Combined License Application Review Levy Nuclear Plant Units 1 and 2

**Safety Panel
July 28, 2016**

Field Data on Void Dimensions

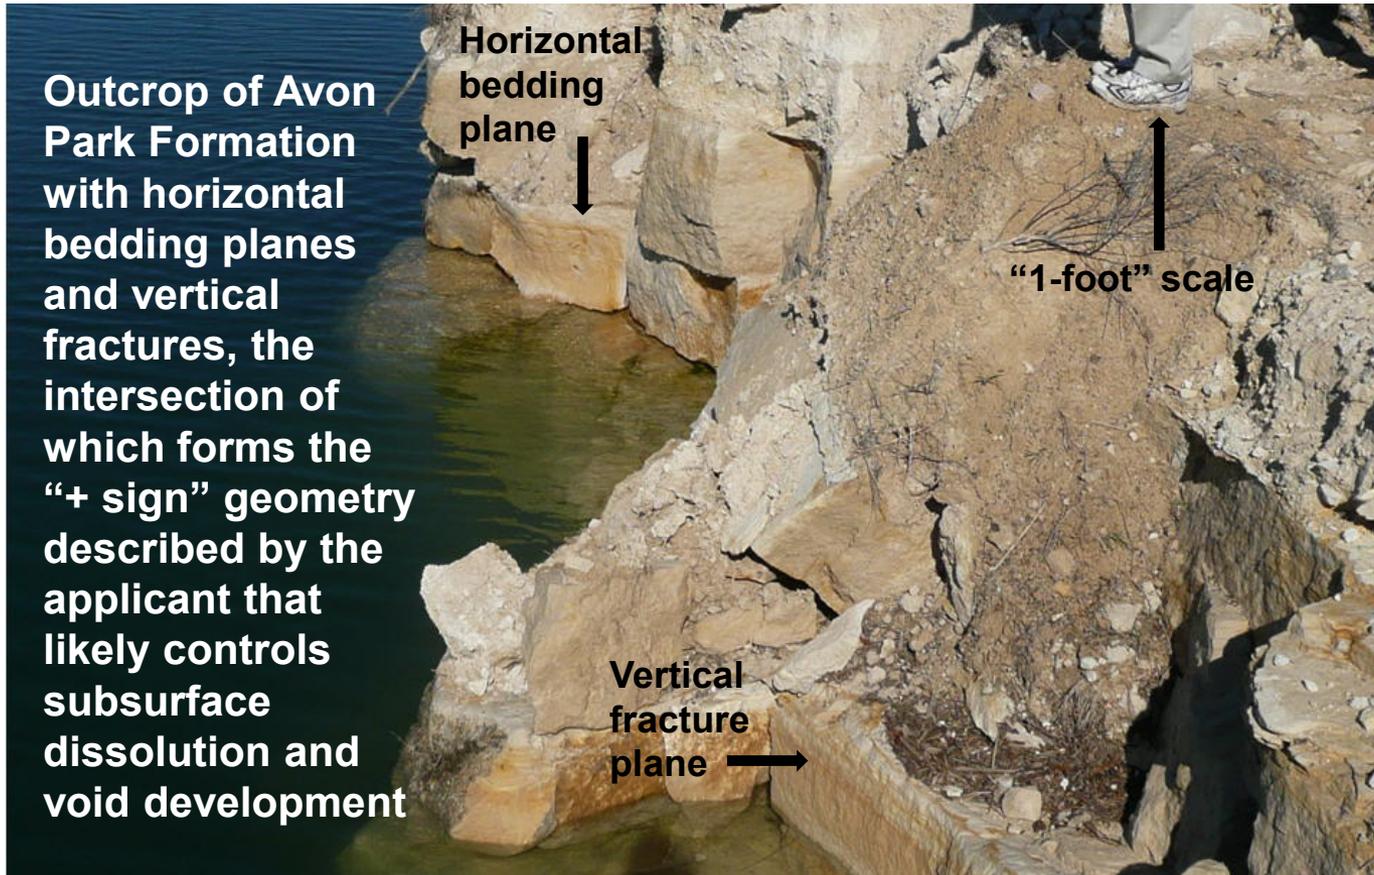
- **Applicant determined that dissolution voids in the Avon Park Formation were <1.5m (5ft) in vertical dimension [based on measured lengths of rod drops in boreholes] with a maximum horizontal dimension of 1.6m (5.3ft) [based on grout uptakes measured during grout testing].**

Staff Conclusions

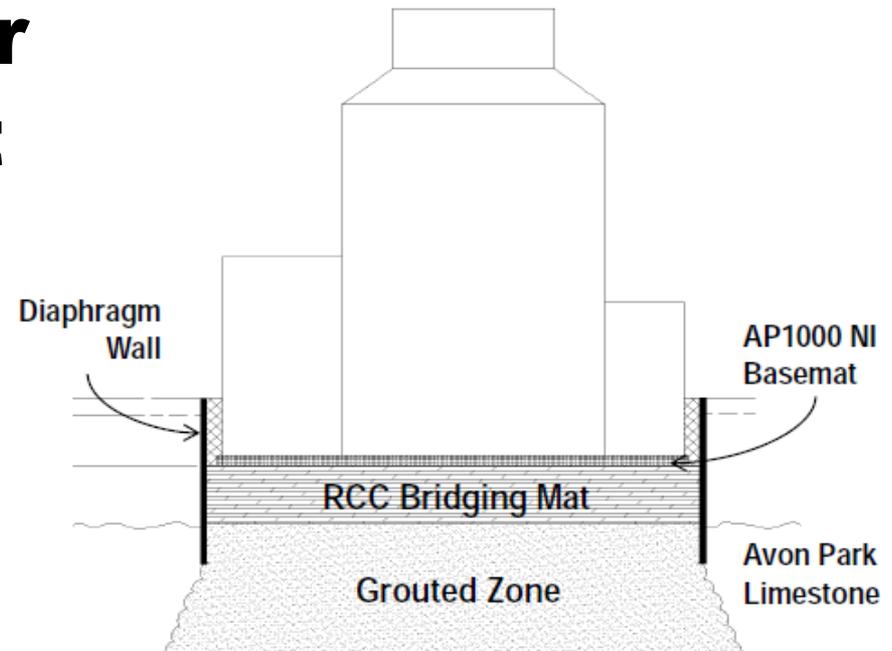
- **Field data support postulated maximum dimensions of dissolution voids in the Avon Park, and the interpretation that majority of voids are not more than 1ft in diameter.**
- **Subsurface voids will not detrimentally affect stability or suitability of the Avon Park.**
